GASCOLATOR RECALL

This Gascolator Recall notice replaces the Gascolator Required Inspection published in February, 2001 *RVator*. This notice also replaces the GAS-3 Gascolator letter dated June 8, 2001.

GASCOLATOR BOWL END VIEW

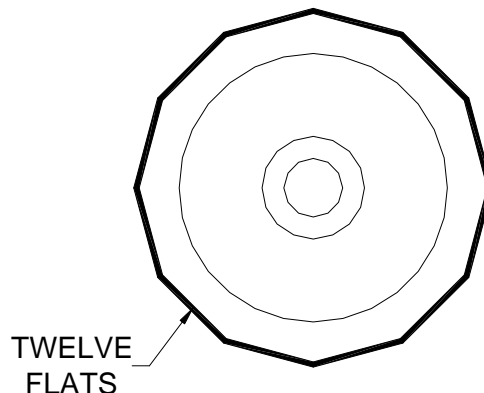
The "OLD STYLE" GAS-3 gascolator bowls differ from "new style" gascolator bowls in the number of flats at the bottom of the bowl. "OLD STYLE" BOWL END CAPS HAVE TEN FLATS. "New style" bowl end caps have twelve flats. Only gascolators with "OLD STYLE" bowl end caps need to be replaced.

OLD STYLE

NEW STYLE

RETURN TO U.E.I.

NOT AFFECTED BY RECALL
